VA259-14-R-0009 ANSWERS TO BIDDERS QUESTIONS
Physical Medicine & Rehabilitation Services (PM&RS) and Prosthetics Center

1 FIRST FLOOR - FLOOR GRILLE DIMENSIONS
1/4" = 1'-0"

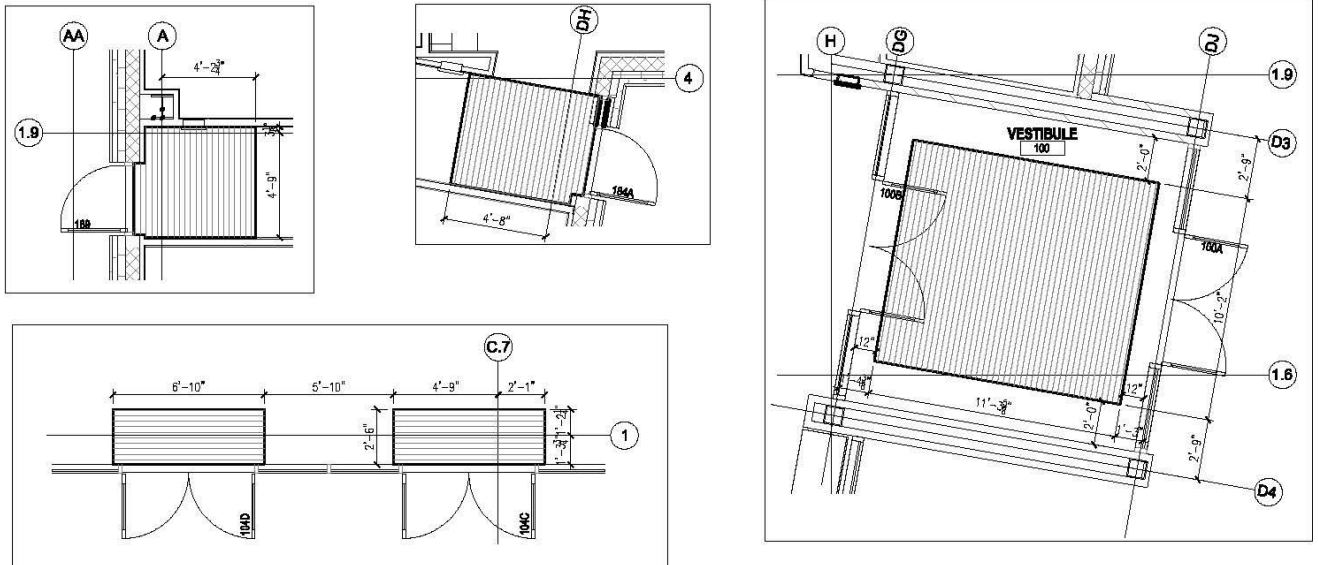
4. **Question:** In drawing 38-SF-101 note 5 – See architectural plan for sizes and locations while in drawing 38-AI-101 Entrance floor grilles, see structural for dimension. Please provide sizes for the entrance floor grilles and specification.

Answer: For size of entrance floor grilles see sketch SK-1 below and specification Section 09 06 00, Finish Materials Schedule: 12 4816 Floor Grilles Construction Specialties “Peditred WR G4” 7304 Sandstone or Acceptable Substitution.
